PLANNING COMMISSION AGENDA

TO: [AGENDA_OFFICIAL_BODY]
FROM: Marcia Strange, Director of Community Development
DATE: November 12, 2025
SUBJECT: 775 Industrial - Tiger Towing and Self Storage Site Plan Review

SITE DEVELOPMENT PLANS
NOVEMBER 03, 2025

Plan View
Scale - 1" = 30ft

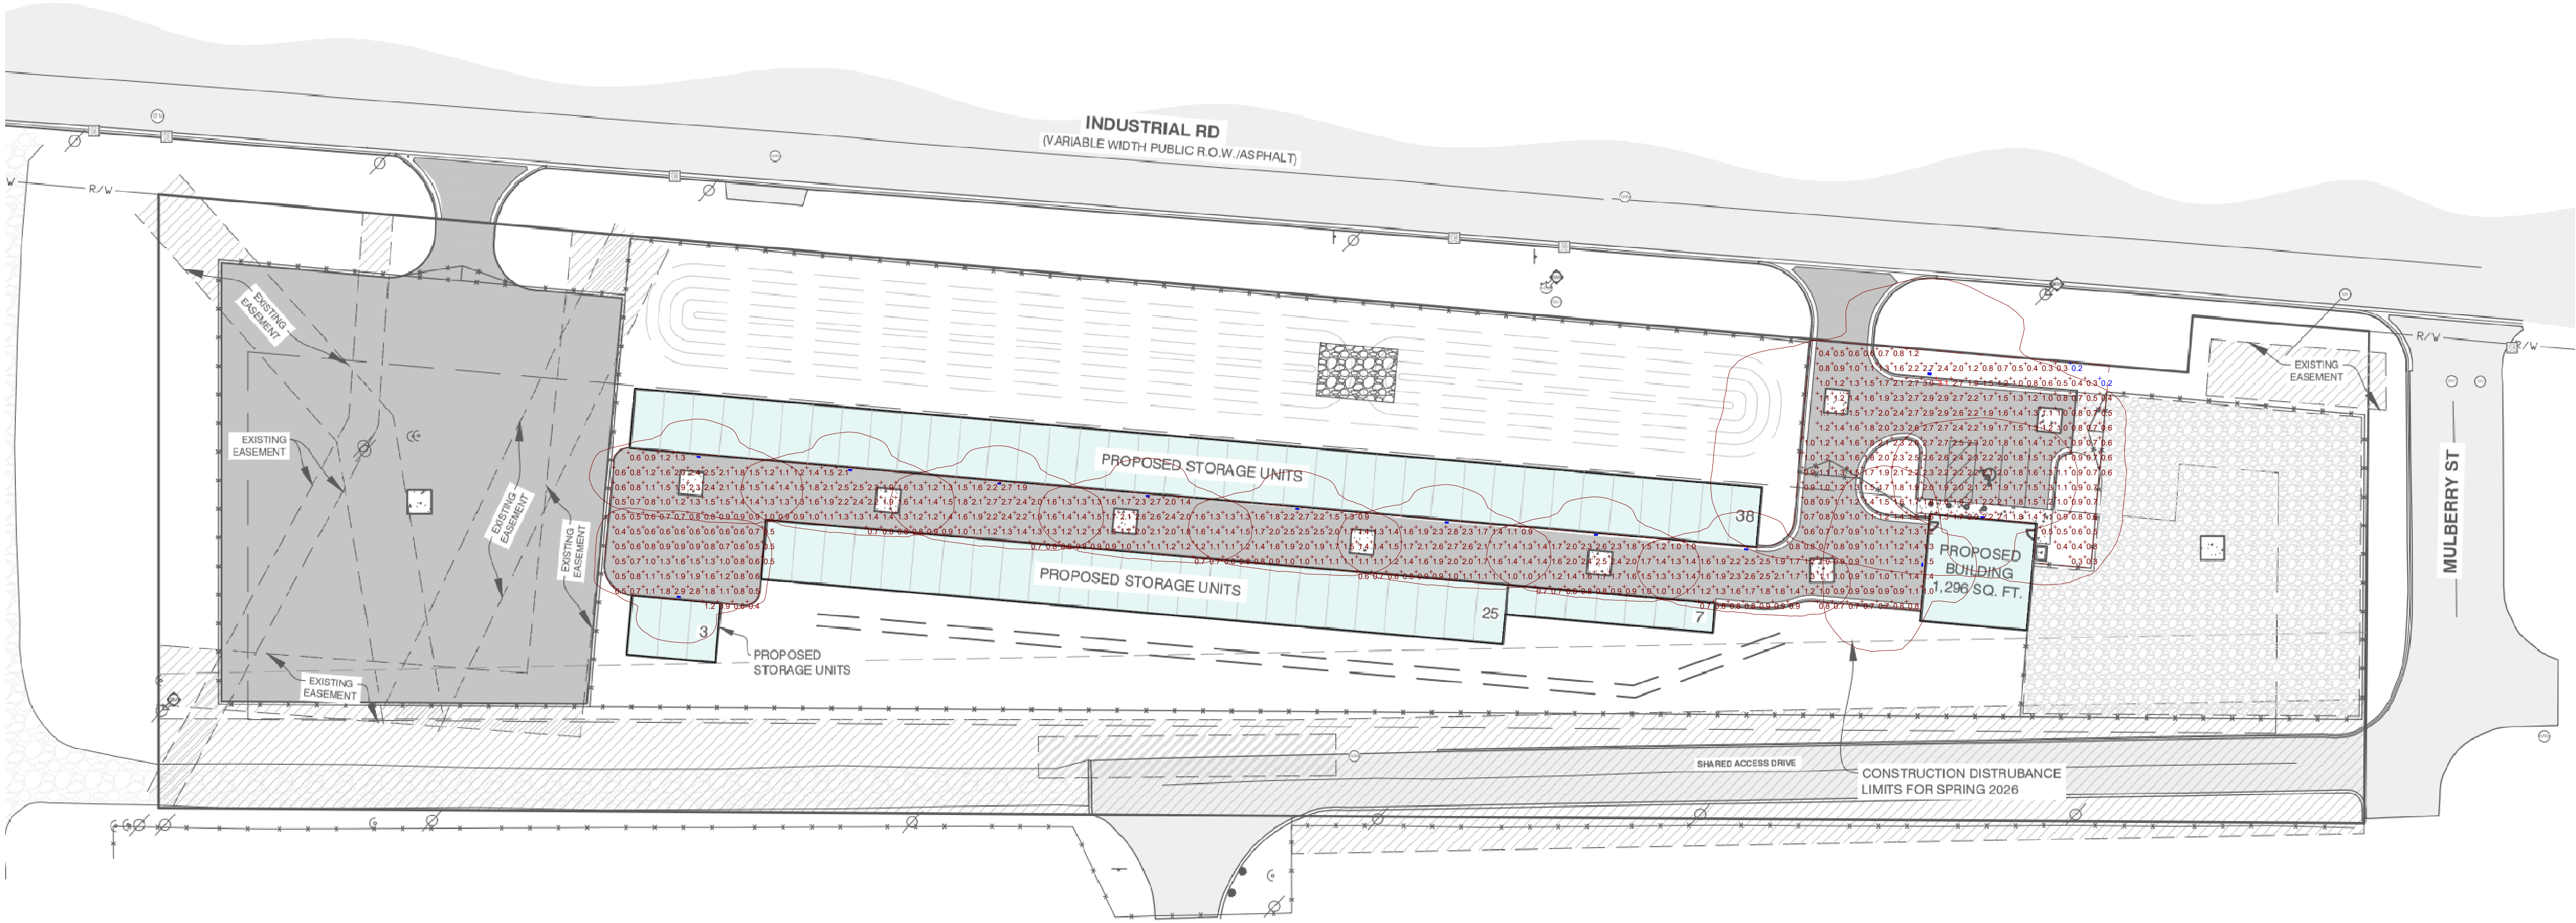
Stormwater review recommended some contingencies that the applicant has responded to but has not been able to make adjustments to the plan in time:

1. Stormwater management system should be redesigned to provide one foot of freeboard between the pond high-water level and the top of the berm.

2. Plans should be revised so that existing catchbasin CB-4 should either be replaced, or have the proposed outlet connect to a new proposed catchbasin located on the 24" concrete pipe that outlets from CB-4 to the southwest.

4. The developer needs to ensure all Due Care Plans requirements are followed during construction to prevent exposure to any contractors.

There are no other sidewalks in the area, it is staff recommendation to allow the project to be approved without sidewalk, reserving the right to require it if adjacent properties add sidewalks. Grading allows future sidewalk installation.

Staff recommendation is that parking areas should not be overbuilt; self-storage generally has low daily traffic, so excess parking is often unnecessary. Our current ordinance seems to align more with a self-storage structure that houses multiple internal self storage units that make up the "Primary Building". The current capacity easily meets a 1/1000 requirement found in other ordinances (in lieu of the 1/275 in our ordinance). There is also additional room on the site that could be allocated for additional spaces of future parking if needed. The submitting engineer can also provide insight about quantity recommendations for parking.

The current plan would allow for more than that amount parallel parked between the two banks of storage units. These have not been striped and the applicant would prefer to not stripe these to provide flexibility to the users. Direction on the parking requirement should be given, but it is staff recommendation to allow 14 parking spaces, and reserve the area between the Office building and the south units, for future parking, if needed.

Will follow due care. This is outlined on the plans.

Staff recommendation is to approve the project with contingencies for stormwater to be confirmed by City staff, allocate an area for future parking and future sidewalk, and front yard fence to be revised from chain link to a decorative fence, allow relocation of the post and panel sign if a base is added.
